ADDENDUM NO.: 4

PROJECT NAME: **POLICE TRAINING ACADEMY HVAC COMPONENT REPLACEMENT**

DATE: 7/15/2013

CIMS PROJECT NO.: **35-06010**

ENLARGED MECHANICAL FLOOR PLAN - 1ST FLOOR, AREA-B

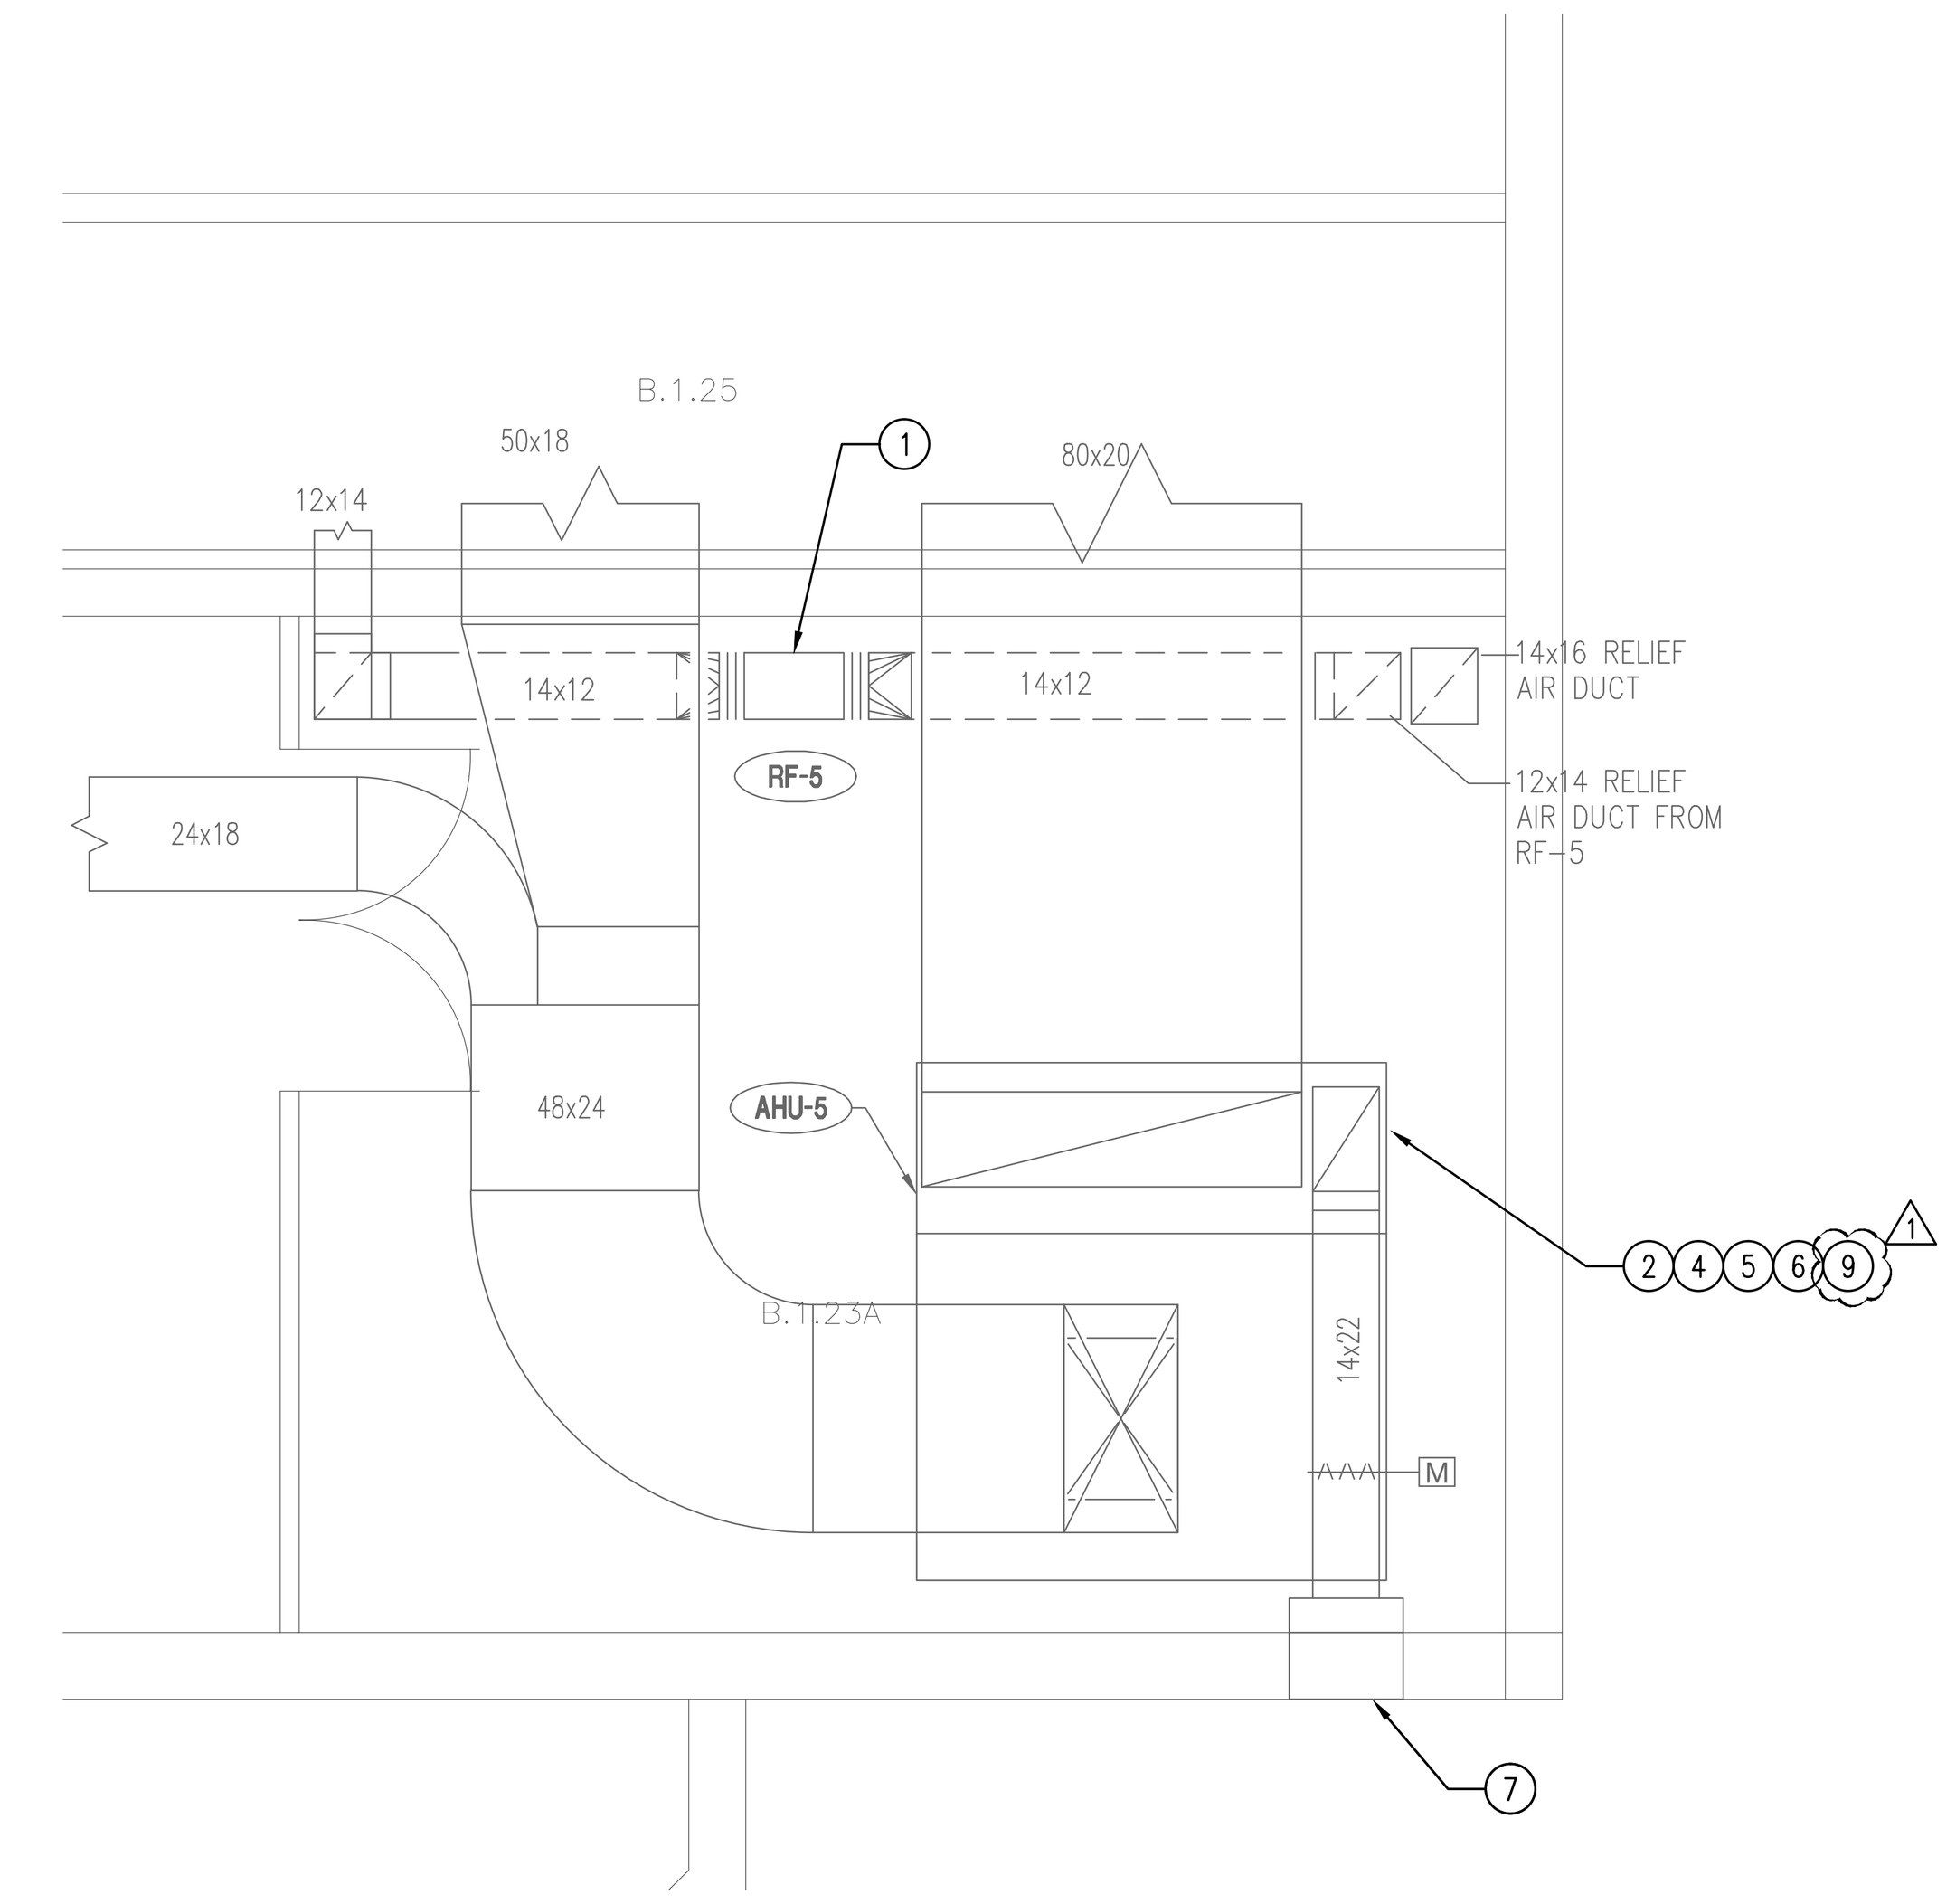
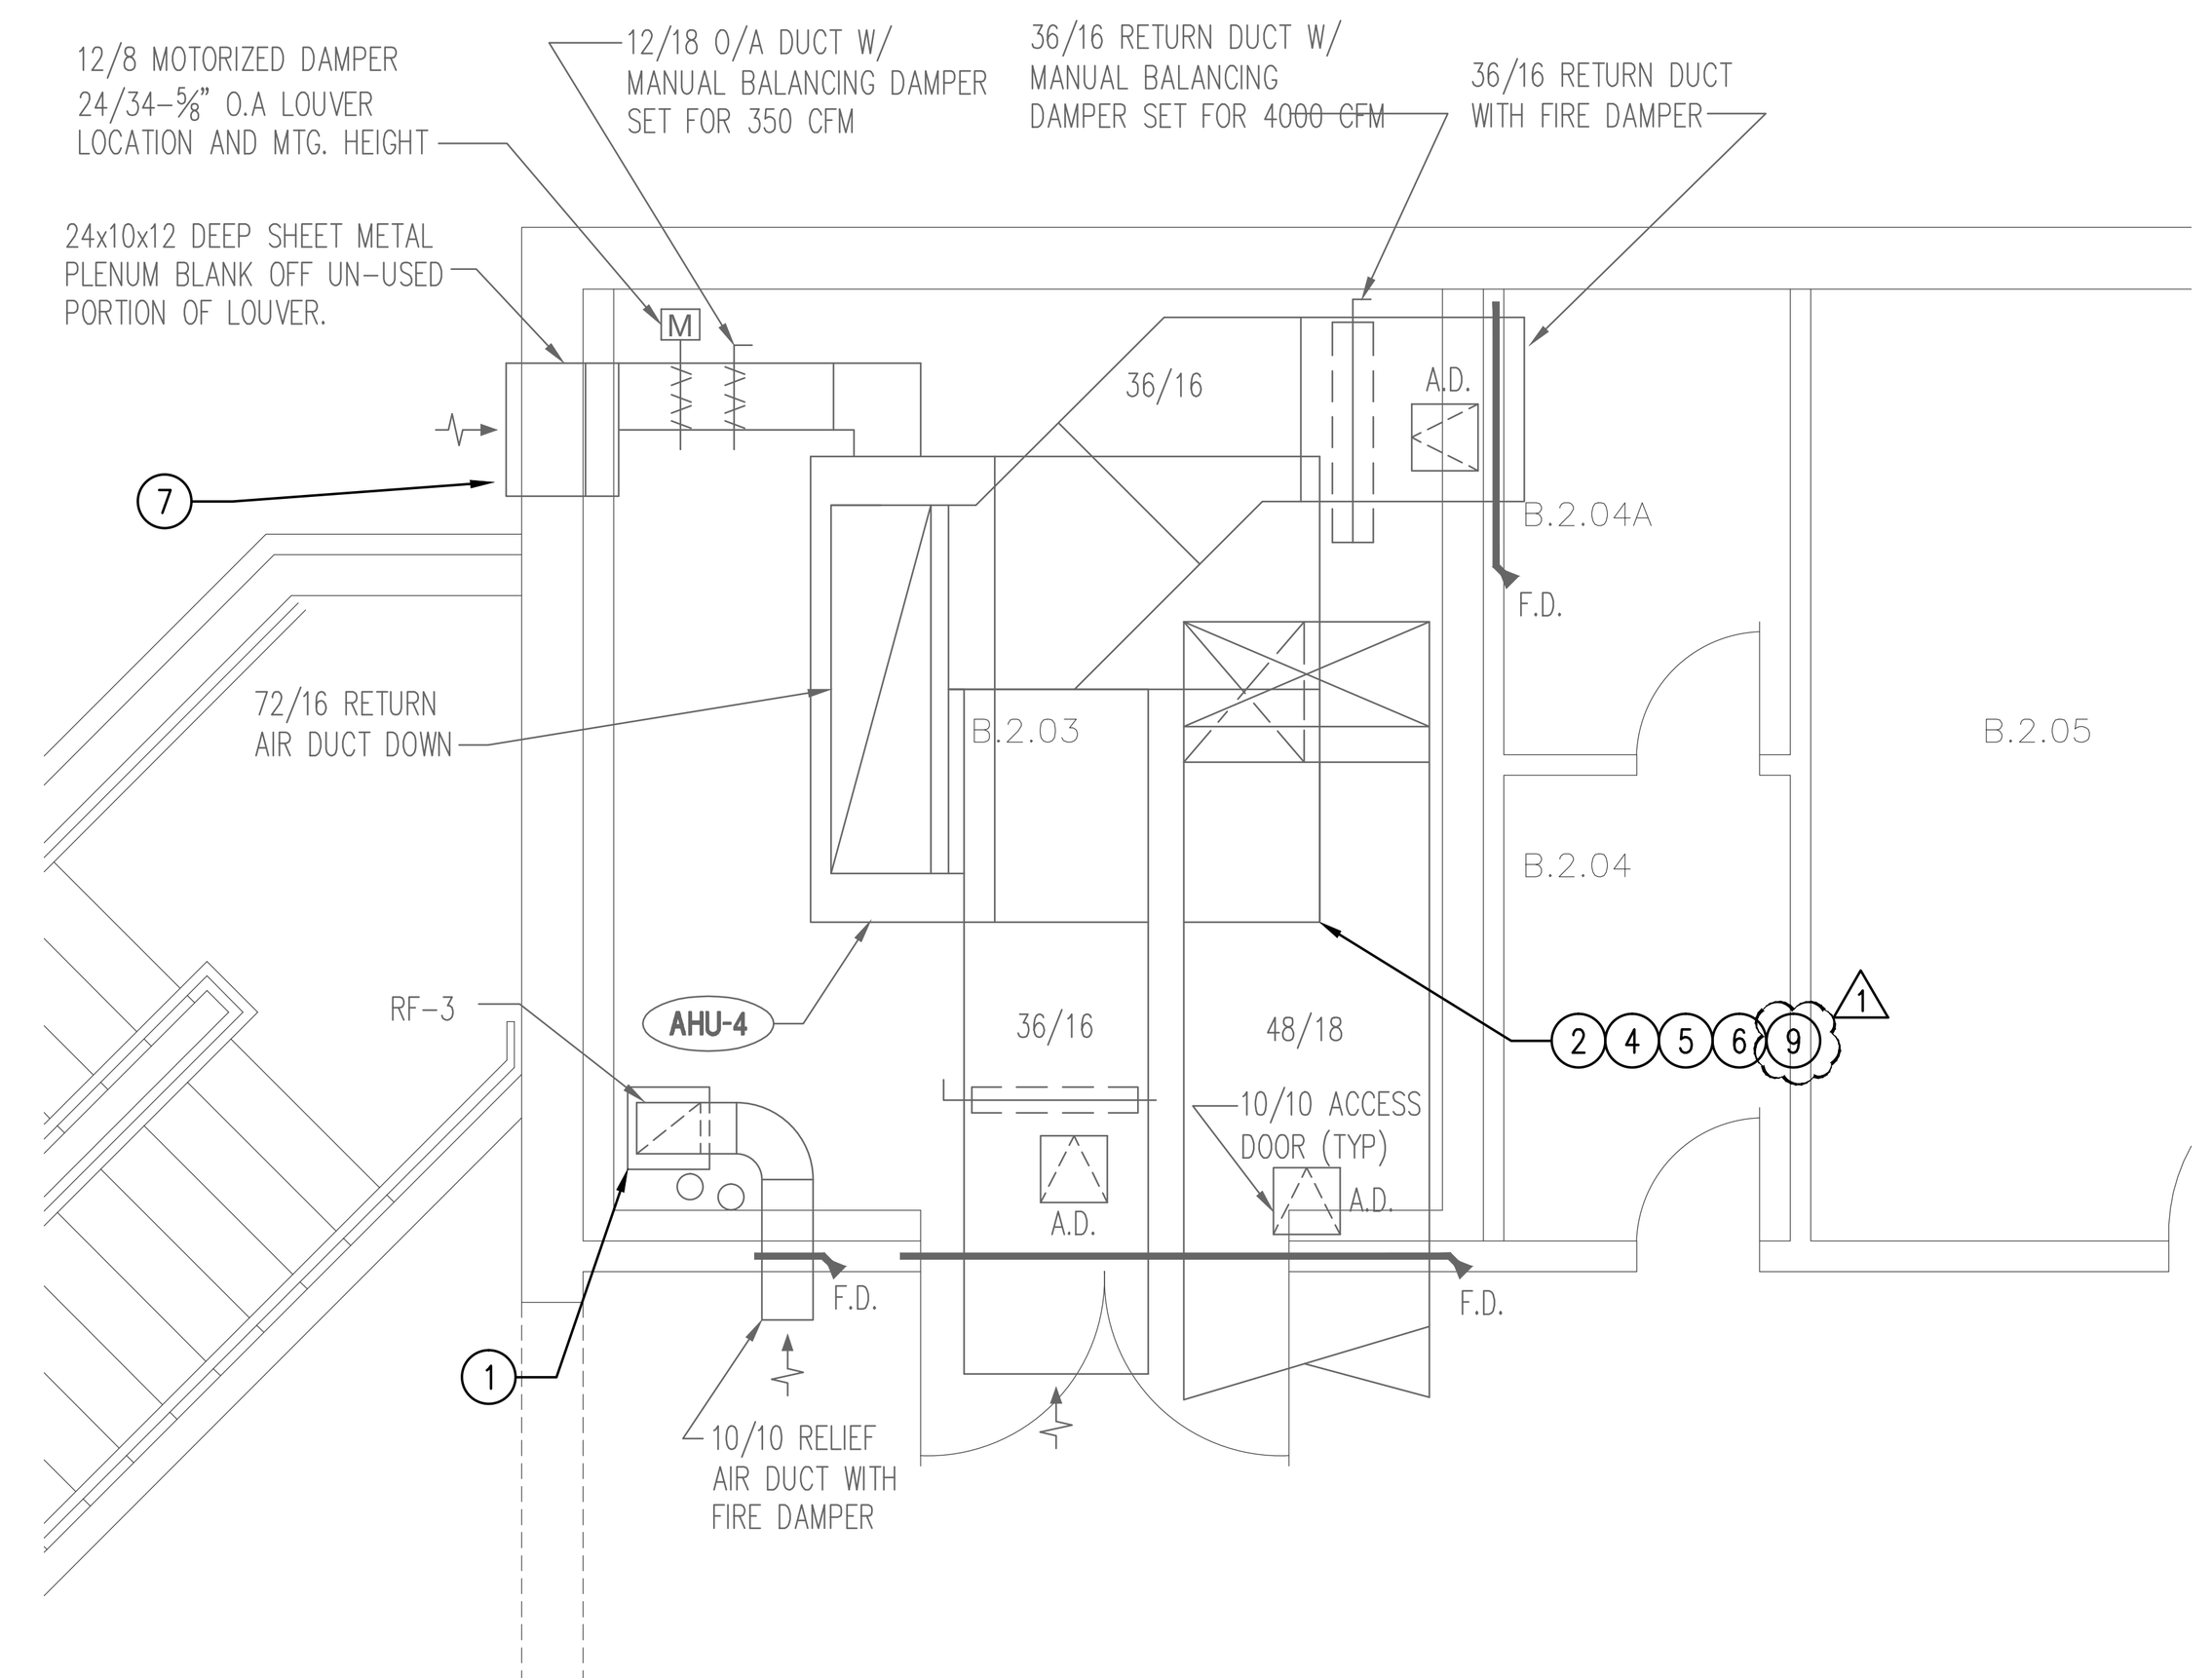
PLAN SHEET MD1.1

- Existing air handling units are to remain. Their respective coils, fan motors, condensate drain pans and piping and internal casing insulation is to be replaced with new.
